**APPLICATION  
FOR PERCOLATION TESTING AND SITE EVALUATION**

SUBDIVISION/PROPERTY NAME \_\_\_\_\_  
 PROPERTY ADDRESS 13755 Burntwoods Rd Glencol 21737  
STREET TOWN ZIP  
 TAX ACCOUNT # 03-297039 TAX MAP 0022 GRID 0007 PARCEL 0094 LOT NO. 1 PROPOSED LOT SIZE (ACRES) 4.27  
 ZONING CATEGORY \_\_\_\_\_ TIER \_\_\_\_\_

13755 Burntwoods Road – Notes for perc repair

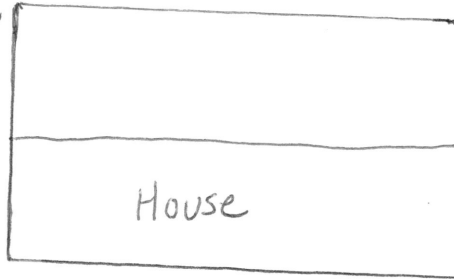
- 7/1/2025 site evaluation for perc test performed. Existing septic tank 1250gallon, with approximately 2 ft cover. The absorption system is a seepage pit, full to lid, no surface discharge present.
- Perc test performed just beyond fence, downhill of existing existing/seepage pit. 1.2 loading rate found. Was able to lay out 2 trenches just above existing perc test A.
- 7/3/2025 Installer called to explain homeowner wanted system to be sized for 6 bedrooms. Trench design spec's to remain the same, 2 ft wide, 8 ft bottom, effective area starting depth 4.5ft. For a 6 bedroom design, trenches will extend in length to 150 ft instead of 125 ft. Ok for installer to restake in field and submit on design plan for review and approval. -KMW
